Access Compliance Report Public Rights-of-Way (Curb Ramps)

Main Street: MAYBECK_LN **Cross Street:** O_NEILL_DR **Location:** SW

ADA ID: RPRK211025121757 **Ramp Type:** Type 1 - Perpendicular Diagonal Initial Pass/Fail: Pass **Overall Compliance:** No **Severity Score:** 19

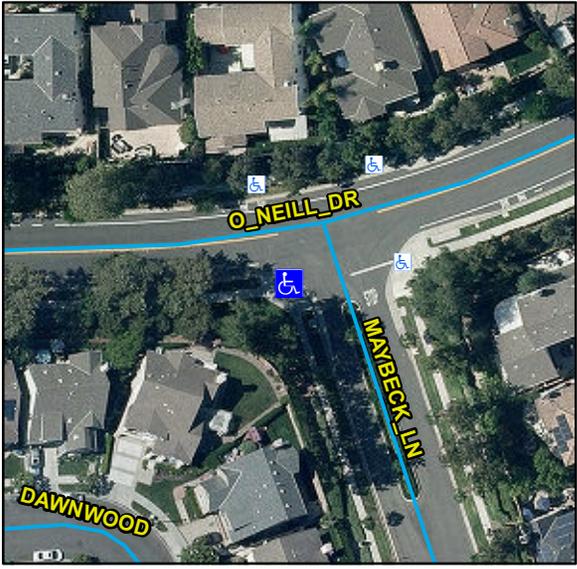
Compliance	Description	Data	Compliance	Description	Data
N/A	Ramp Length (in)	119	N/A	Flare Type LT	
Yes	Ramp Width (in)	48		Flare Slope LT (%)	3.2
Yes	Ramp Run Slope (%)	7.5	Yes	Flare Traversable LT	Yes
Yes	Ramp Cross Slope (%)	1.2	N/A	Flare Type RT	
N/A	Landing Present	Yes		Flare Slope RT (%)	6.3
N/A	Landing Length (in)	39	N/A	Flare Traversable RT	Yes
Yes	Landing Width (in)	48	Yes	DWS Provided	No
No	Landing Run Slope (%)	5.7	N/A	DWS Contrast	N/A
Yes	Landing Cross Slope (%)	1.2	No	DWS Length (in)	N/A
N/A	Landing Movement Obstructed?	No	N/A	DWS Full Width	N/A
	Landing Movement Type	N/A	N/A	DWS Offset Left (in)	N/A
N/A	Landing Shared	No	N/A	DWS Offset Right (in)	N/A
N/A	Clear Space	Yes	N/A	Marked Crosswalk 1	No
N/A	Clear Space To Crosswalk (in)	48	N/A	Crossing 1 Direction	E
N/A	Marked Crosswalk 1	No	N/A	Crossing 2 Direction	N
	Marked Crosswalk 1 Width (in)	N/A		Marked Crosswalk 2	No
N/A	Ramp Inside Crosswalk 1	N/A	Yes	Marked Crosswalk 2 Width (in)	N/A

Crossing 1 Slope (%)	1.9		Ramp Inside Crosswalk 2	N/A
	Crossing 1 Cross Slope (%)	0.7		Crossing 1 Slope (%)	2.6
Yes	Gutter Ponding	No	No	Crossing 2 Slope (%)	1.2
Yes	Gutter Lip Height (in)	0		Crossing 2 Cross Slope (%)	13.7
Yes	Gutter Run Slope (%)	4.5		Curb Slope	1
No	Gutter Cross Slope (%)	2.1		Road Run Slope (%)	0.8
Yes	Overall Surface Condition: Acceptable		No	Road Cross Slope (%)	
	Cross Gutter Present?	No		Perp Joint Present	No
	Replace Cross Gutter?	N/A		Spandrel Present?	No
				Replace Spandrel?	N/A

Possible Solutions:
Remove & Replace Curb Ramp With Two New Directional Ramps or Equivalent. Remove & Replace Gutter.

OC Std/PROW:
 R304.2.2, R204.3, R304.2.1, R304.2.2-Perp, R304.3.2-Para, R305, R304.5.3, STD 1115
